**2-D-25-HZ**  
**APPLICATION FOR CERTIFICATE OF APPROPRIATENESS**

1235 Armstrong Ave. 37917  
 Old North Knoxville H

# Staff Report

File Number: 2-D-25-HZ

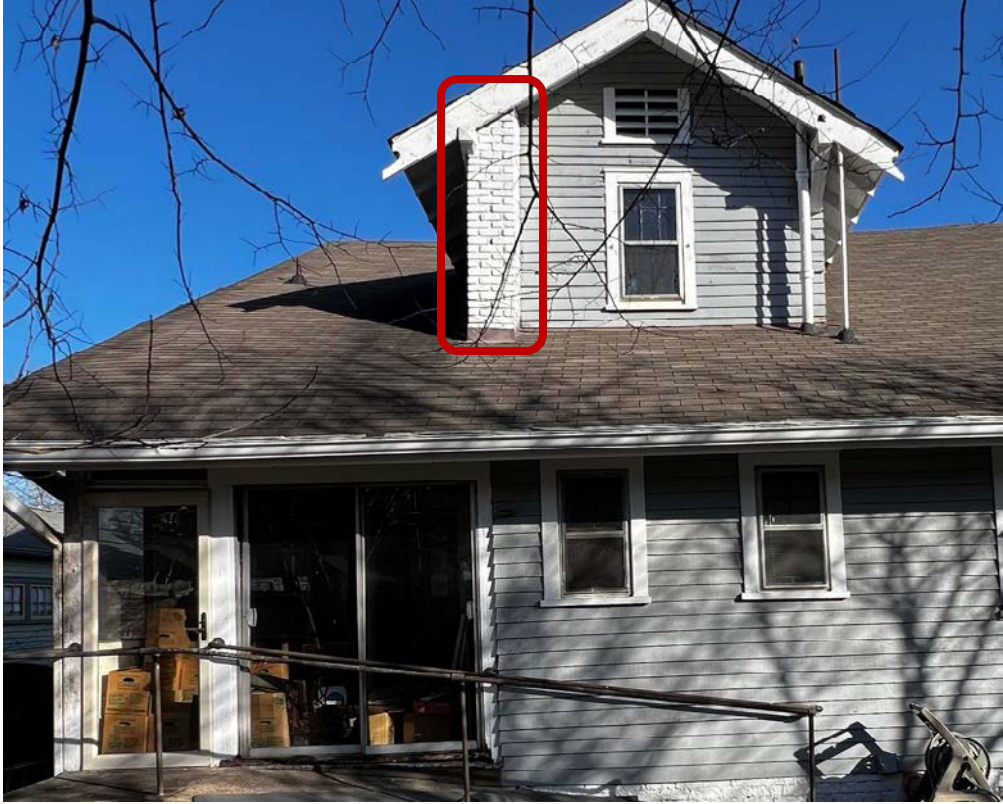
Replace non-original sunroom windows with two French doors to access the rear yard. French doors to be approved by staff.

Replace two small side and back windows that are currently aluminum with two wood casement windows (one over one or single pane).

6. The application proposes to enclose the already-enclosed sunporch with more appropriate lap siding and French doors, requesting staff to approve the French door specifications at a later date. As the French doors are not visible from the right-of-way, staff level approval is appropriate.
